**Auckland Council District Plan**  
**(Operative Auckland City – Central Area Section 2005)**

**PROPOSED PLAN MODIFICATION No. ##**

Under Schedule 1 of the Resource Management Act 1991

### Planning Overlay Map 3 – General Height Controls

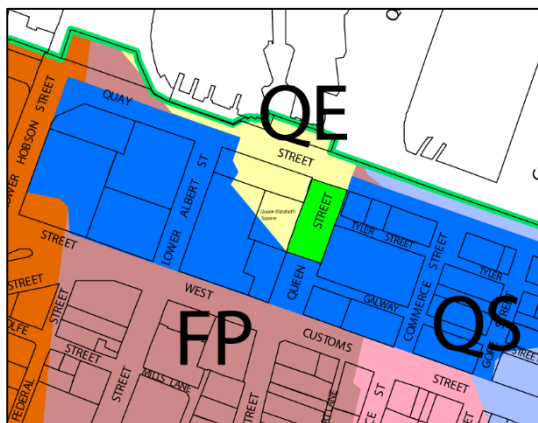
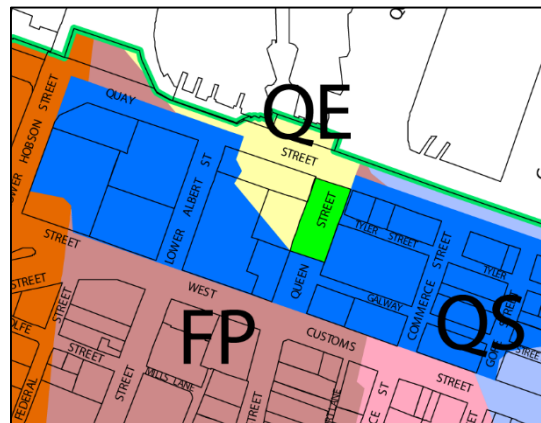
1. Delete 'Queen Elizabeth Square' text
2. Add 'Special Height Control Only' to area shown as

### Planning Overlay Map 4 – Special Height Controls

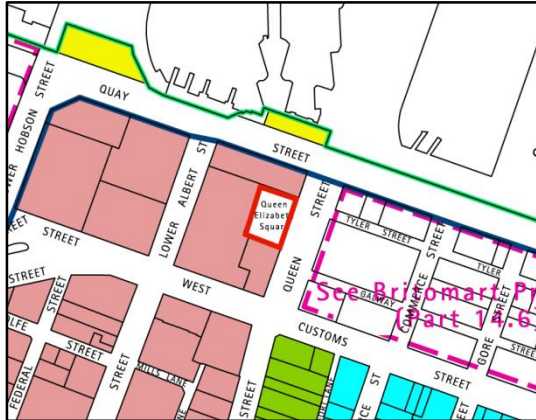
1. Delete 'Queen Elizabeth Square' text

## Planning Overlay Map 5 – Site Intensity

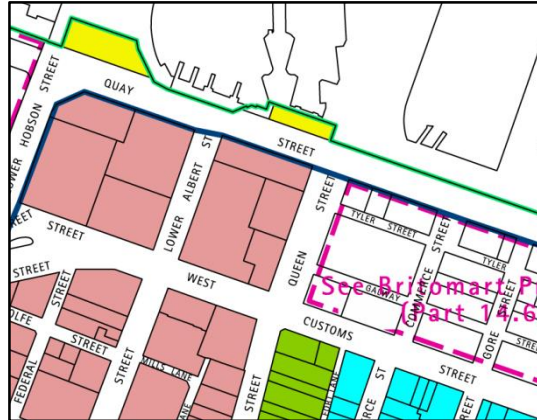
1. Delete 'Queen Elizabeth Square' text
2. Add 6:1 BFAR and 13:1 MTFAR to area shown as

## Planning Overlay Map 6 – Designations, Heritage Items & Additional Limitations

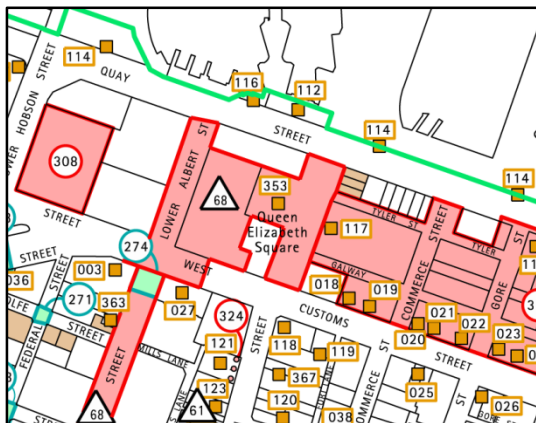
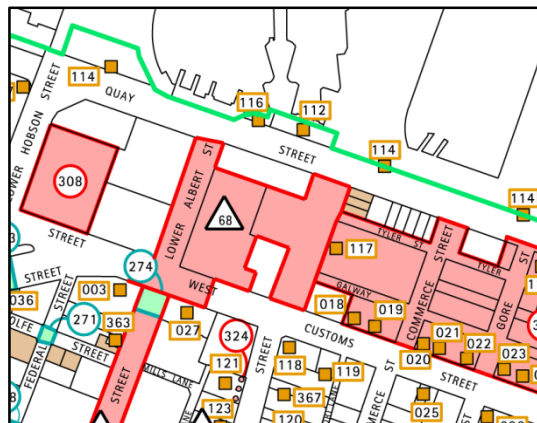
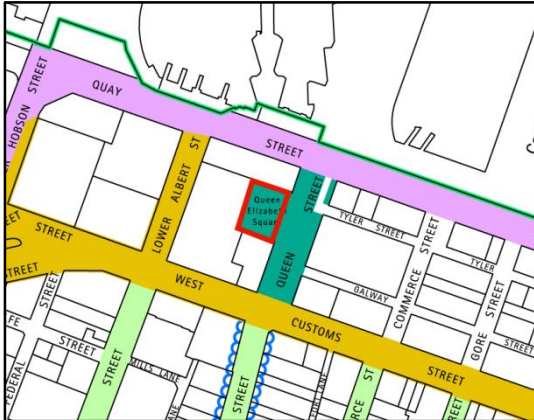
1. Delete 'Queen Elizabeth Square' text
2. Delete item '353'

## Planning Overlay Map 7 – Transportation Controls

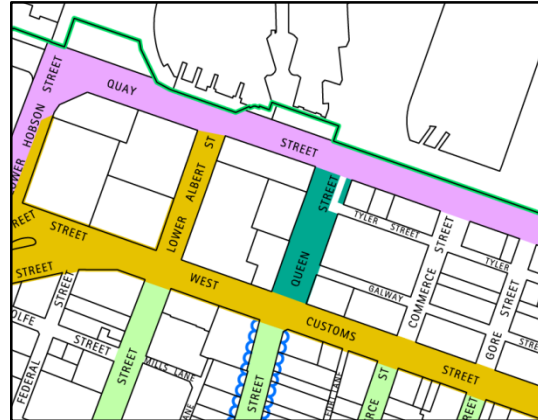
1. Delete 'Queen Elizabeth Square' text
2. Delete 'Pedestrian Mall' from area shown as

5. Insert new Figure 6.17 below:

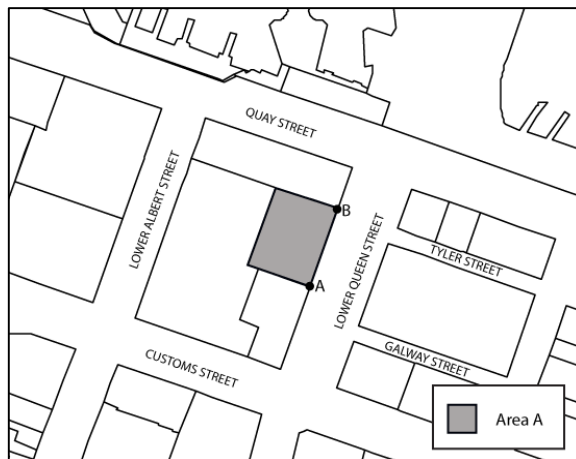
- a) For 'Area A', identified in Figure 6.17 below, any new building must comply with the following:
  - i. The building must adjoin the entire length of the frontage between points A and B, excluding pedestrian accesses.
  - ii. The building must have a minimum height of 19m for a minimum depth of 6m from the frontage.
